Annex-1

Circa 2009 Front Porch & Balcony

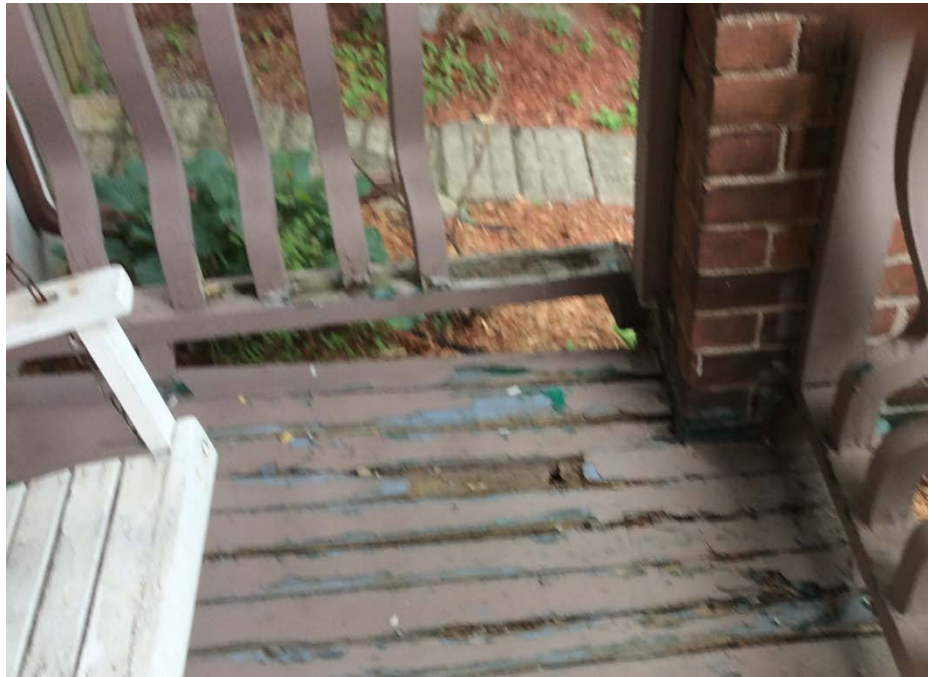
Brick column $\pm 4\%$ incline needs leveling
Also, verify footing cracks

Joint failure & damaged brick

Damaged deck board
To be replace also rail
system

Damage to crown & column base

Damage to balcony floor deck
